RESPONSE TO SUBMISSIONS

RESPONSE TO SUBMISSIONS
FORMER RACHEL FORSTER HOSPITAL
NOS. 134 – 144 PITT STREET, REDFERN

PREPARED FOR KAYMET CORPORATION PTY LTD

JUNE 2017

Figure 7

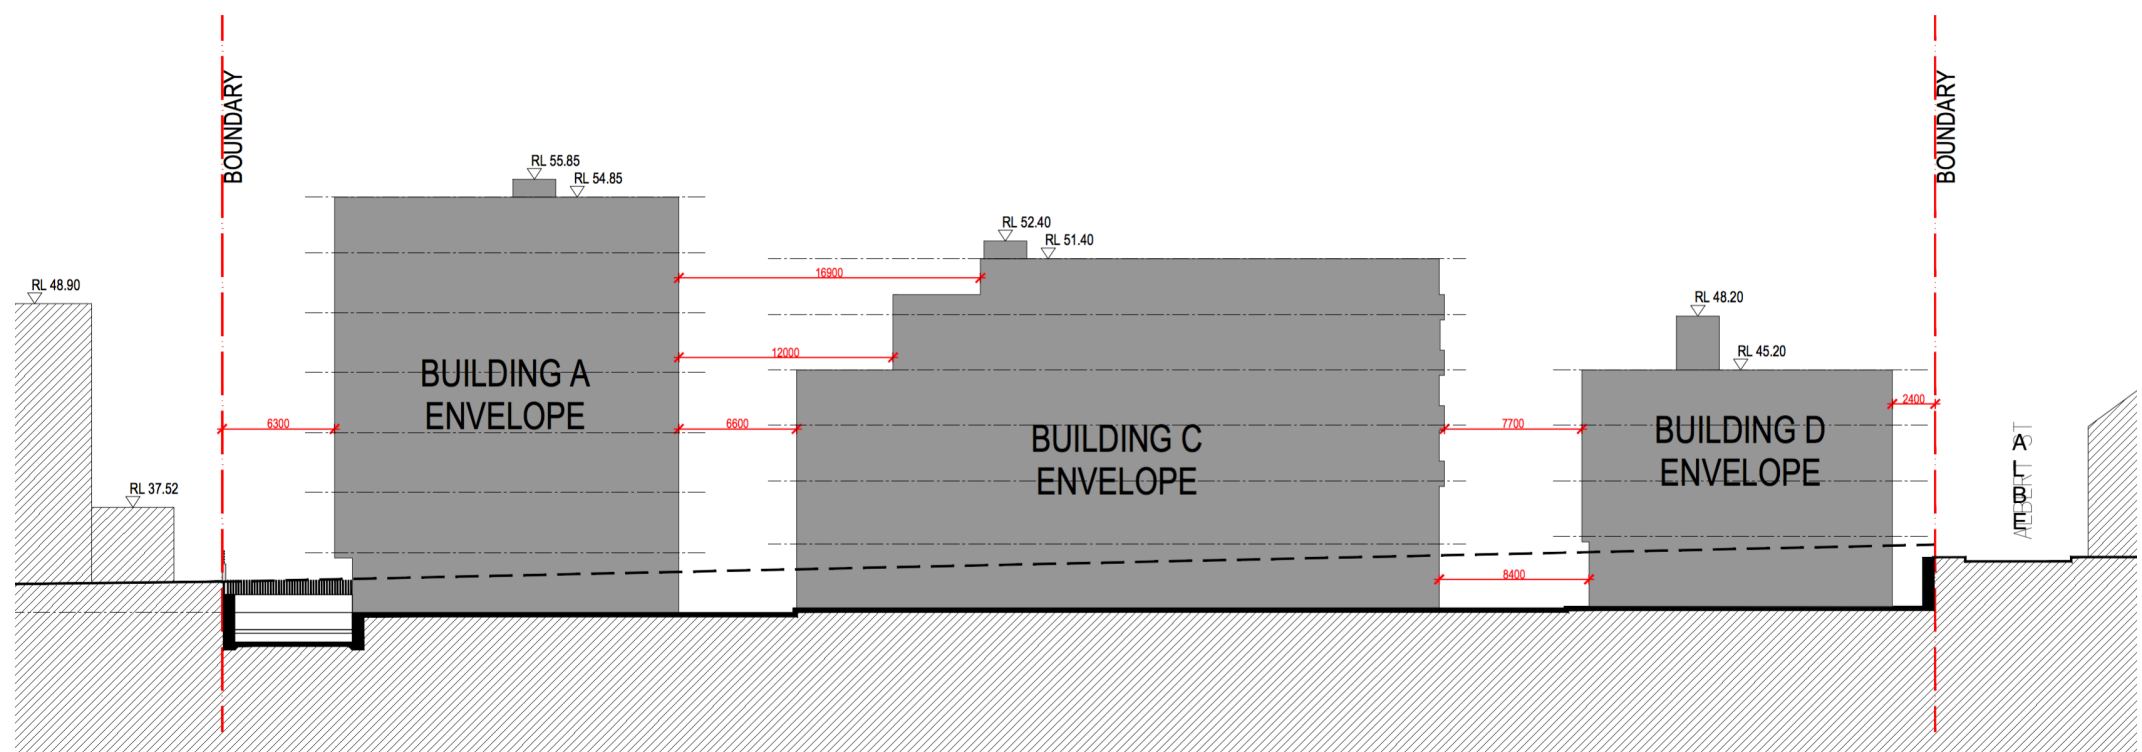
The overall height of Building B will increase from 4 storeys to 6 storeys. Building B will remain obscured from view from both Pitt and Albert Streets by Buildings C and D. This RTS includes further modulation to the upper levels of the built form to ensure its subordination to the Rachel Forster Hospital building (see **Figure 7**).

Extract from RTS Concept Plan modification, increasing the height of Building C, and illustrating the additional modulation now proposed in the built form at the building's upper levels.

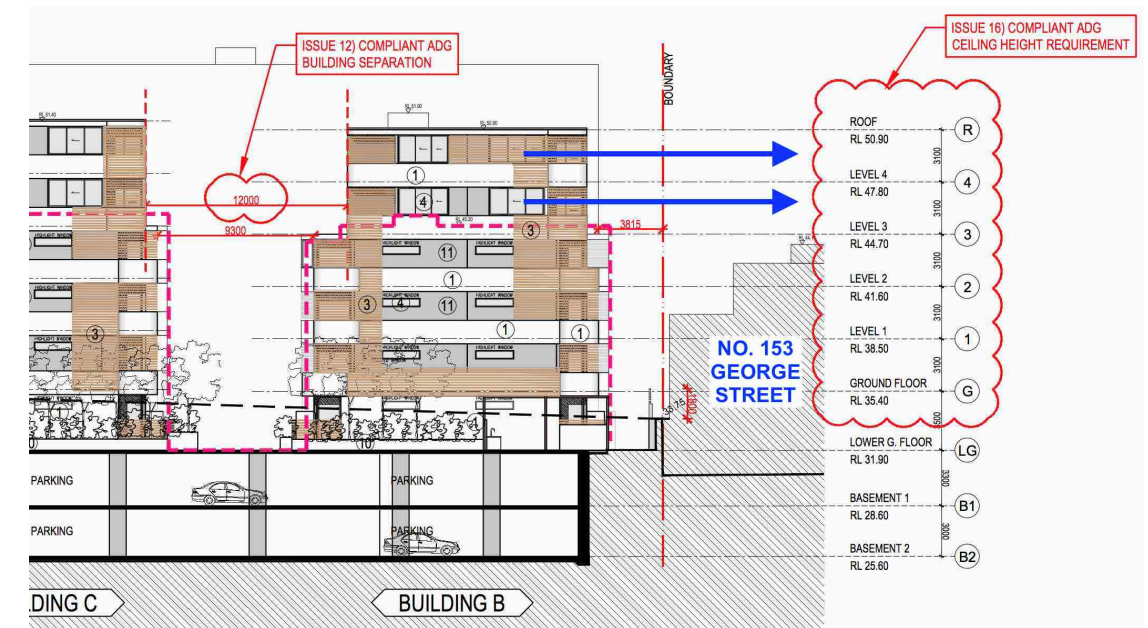
Recommended building separations are not achieved between the introduced upper levels of Building B and the recently completed building at No. 153 George Street. The proposed modifications do not however introduce windows into any elevation in which they were not previously approved. The increase in height of Building B will not therefore significantly contribute to overlooking of this property, which is built to boundary, oriented to the north and south, and has limited openings upon its eastern elevation (see **Figures 12 – 14** over page).

living area and master bedroom are oriented to the north. The 3 lower levels of this residential building are oriented north and south only. As can be seen in **Figure 13**, the additional Levels 3 and 4 proposed atop Building B are at a level where there will be no direct privacy conflict with No. 153 George Street, given the height and offset nature of the proposed new windows, and the limited number of windows upon the eastern elevation of the established development at No. 153 George Street (see **Figures 12 and 14**).

Figure 15

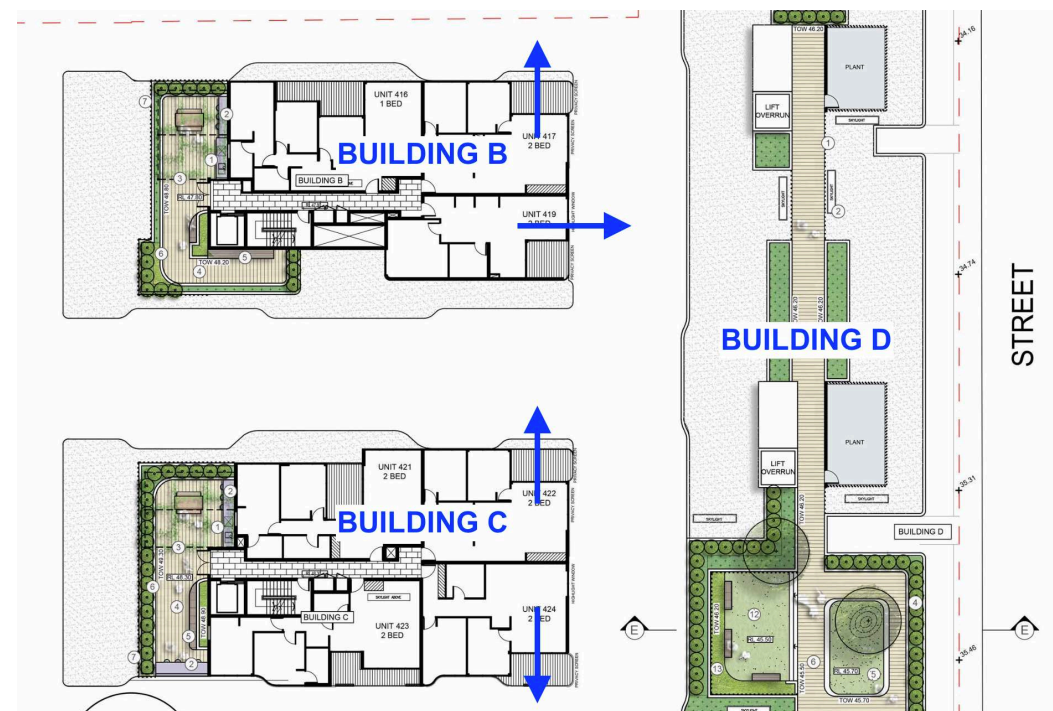
Through orientation of the living rooms, fenestration, changes in building level and incorporation of landscape screening to the communal open space atop the roof of Building D, the setbacks between Buildings B and C to Building D raise no issue in relation to privacy separation (see **Figure 15** below).

Separation of Building's B and C to Building D at the upper levels.
